PROPOSED SUBDIVISION - HAPPY VALLEY

REPORT ON GEOLOGICAL INVESTIGATION

Client: State Planning Office

Rept.Bk.No.71/169

Fig. 2

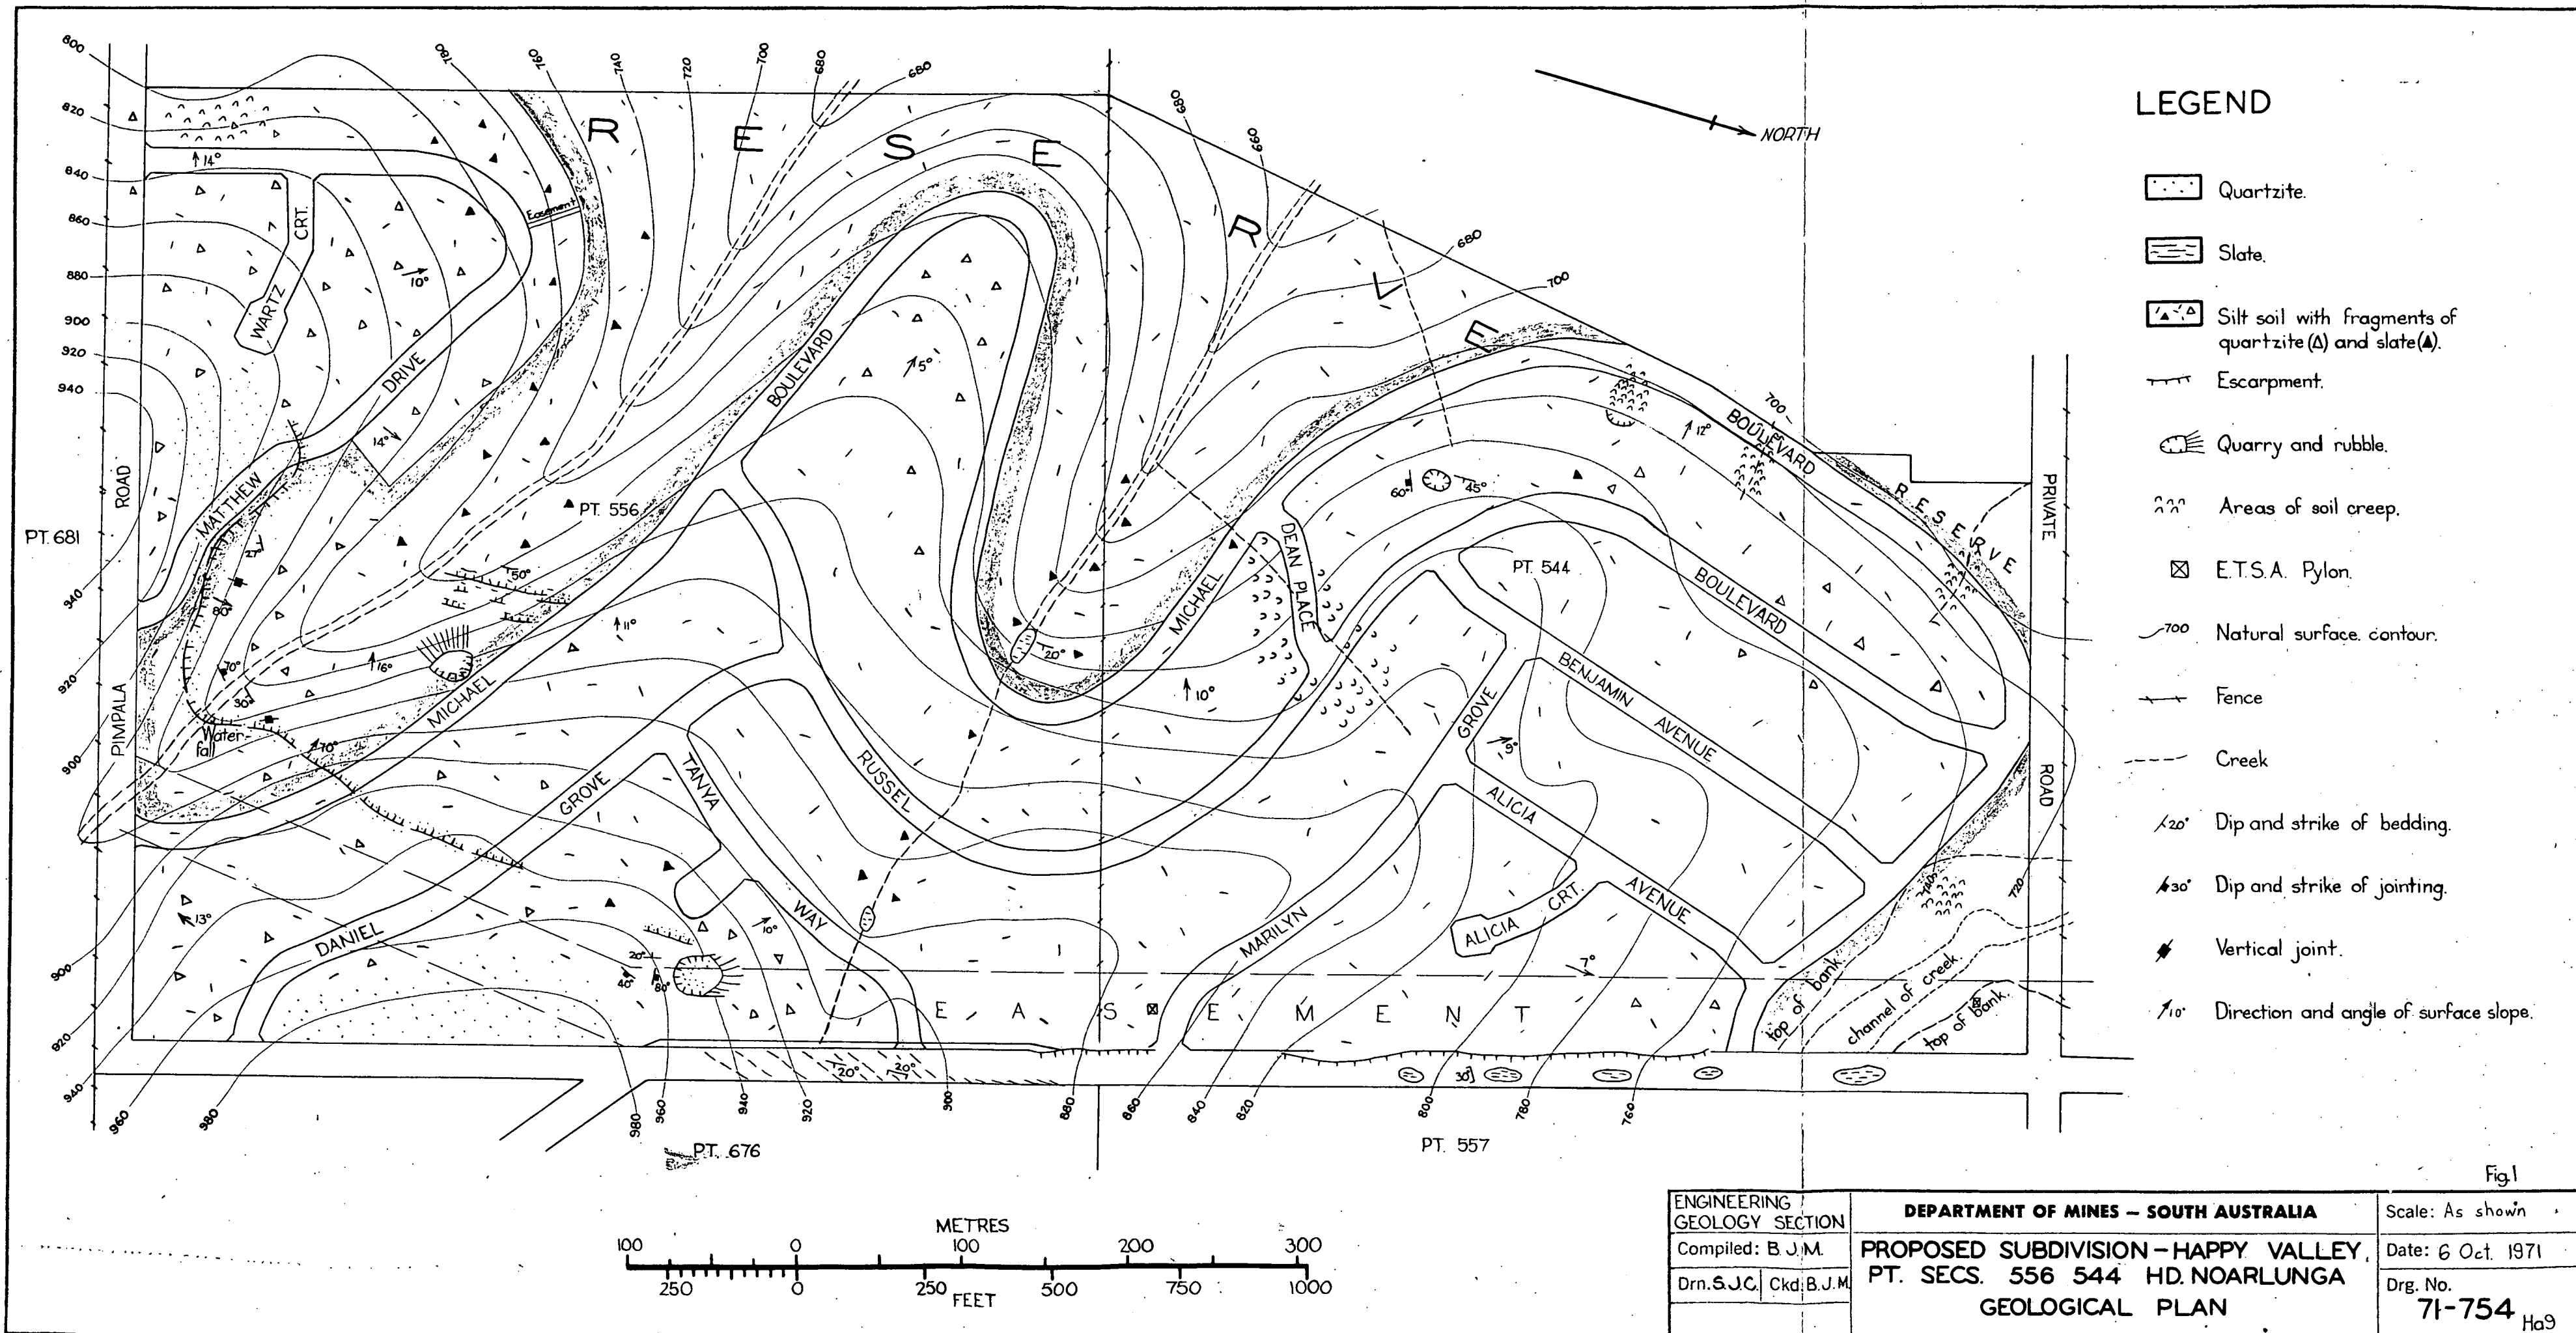
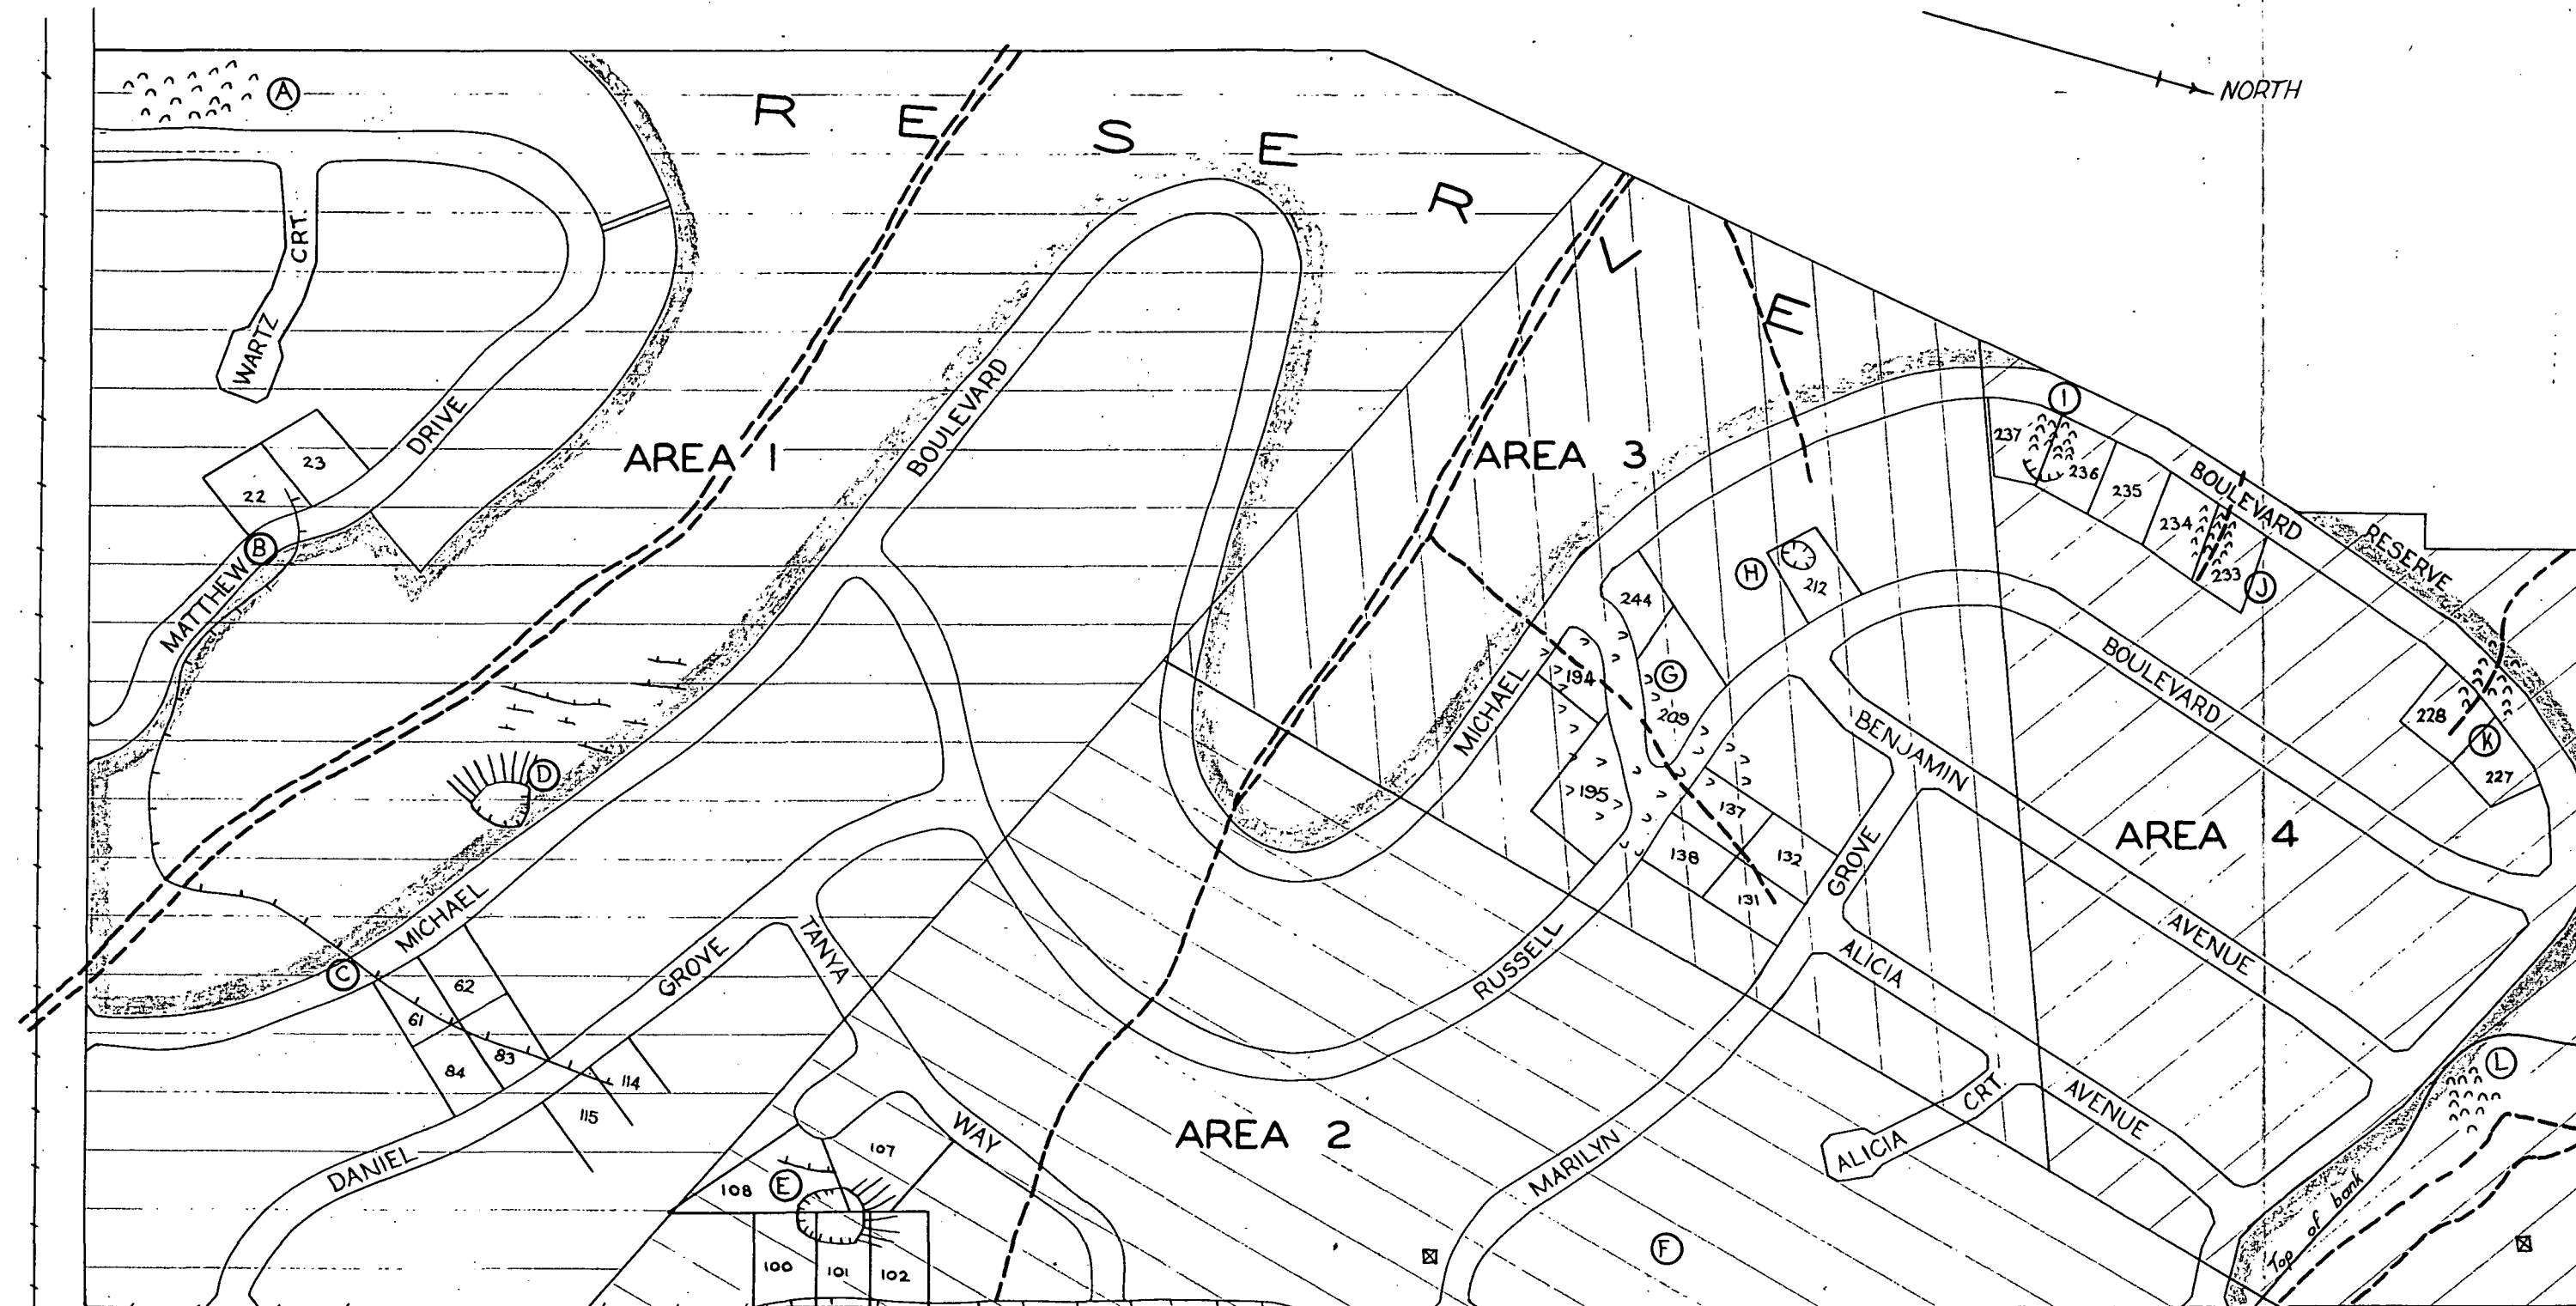
This area has generally stable slopes within the proposed residential area. In the vicinity of point A (Fig. 2), which is the head of a valley, there is considerable active soil creep in the saturated top soil. However bed rock lies close to the surface (within 2ft. (60cms)) and it is considered that with adequate drainage during construction this area should be suitable for building.

In the vicinity of point B the 40ft. (12m) high almost vertical quartzite escarpment comes within 10ft. (3m) of the proposed road way. However the escarpment appears to be quite

stable with no likelihood of major rock slides or erosion under cutting the road way. It is suggested that a safety fence be constructed from about point B to point C along the escarpment. The escarpment as shown crosses lots 22, 23, 61, 62, 83, 84, 114 and 115. If it is proposed to back fill these areas to make the surface level then it is recommended that no building be founded partly on fill and partly on rock as differential settlement could occur beneath the building.

At point D is a quarry (Fig. 2) the position of which is only approximate, as it was not shown on the original Subdivision Plan, dated 6th April, 1971, thus it is suggested that its position be accurately located in relation to the allotments. The quarry is 15ft. (4.5m) to 20ft. (6m) deep and the upper 5ft. (1.5m) of the near vertical face, consisting of silt soil and weathered slate, appears to be unstable and subject to minor rock falls. If left unchecked this instability could under-cut Michael Boulevard, hence it is suggested that it be either back filled or the faces battered back to about 45°. Both these alternatives could be easily accomplished with earth moving equipment.

At point E (Fig. 2) there is a quarry up to 15ft. (4.5m) deep. The faces slope at 50° to 60° and appear to be quite stable. If the quarry is to be back filled then all potential buyers of lots 100, 101, 102, 108, and 107 should be informed that an old quarry lies partly beneath these lots, and it is recommended that no buildings be allowed to be constructed partly over the

Just west of this quarry (Fig.2) is a quartzite escarpment from 3ft. (90cms) to 6ft. (1.8m) high. Its position is only approximate as it was not shown on the original subdivision plan dated 6th April, 1971, and it is suggested that it be accurately located. This escarpment appears to lie in lots 107 and 108, and if it is proposed to add fill to make the surface level then it is recommended that no buildings be built across the buried escarpment as differential settlement could occur beneath the building. Also it is suggested that all potential buyers of lots 107 and 108 be informed that a buried escarpment lies on these lots.

In the vicinity of point F is a recent water course that has eroded channels up to 3ft. (90cms) deep. However with provision for adequate drainage this area should be suitable for residential dwellings.

In the vicinity of point G (Fig.2) is a large area of unstable soil up to 6ft. (1.8m) thick which surrounds a deeply incised (6ft. (1.8m)) water course that appears to carry considerable amounts of water during storm activity. This area affects lots 131, 132, 137, 138, 194, 195, 209, and 244, and it is suggested that a drain of adequate capacity be constructed along the existing channel to provide drainage for this area. With such drainage this area should be suitable for building purposes.

At point H (Fig. 2) is a quarry up to 15ft (4.5m) deep with near vertical faces. The upper 3ft. (90cms) to 4ft. (1.2m) of the faces, composed of silt soil and weathered jointed quartzite, appears to be unstable and subject to minor falls. This quarry lies entirely on lot 212 and it is recommended that potential buyers of this lot should be informed that an old quarry lies on this property. It is recommended that no building be founded partly on fill and partly on rock, as differential settlement of the fill may occur, beneath the building.

At points I, J & K are areas of active soil creep. However bed rock appears to be within 3ft. (90cms) of the surface and with suitable drainage during construction on lots 227, 228, 233, 234, 235, 236, 237 and Michael Boulevard these areas should be suitable for residential development.

At point L there is evidence of an old soil slip into the creek and the top of the escarpment comes within 10ft. (3m) of Michael Boulevard. It is suggested that either a) Michael Boulevard should be located at least 20ft. (6m) from the top of the escarpment, and no drainage from the subdivision should be allowed to run into the old slip area, or b) a retaining wall should be constructed around the face of the "bank" to prevent any future slip under-cutting the roadway.
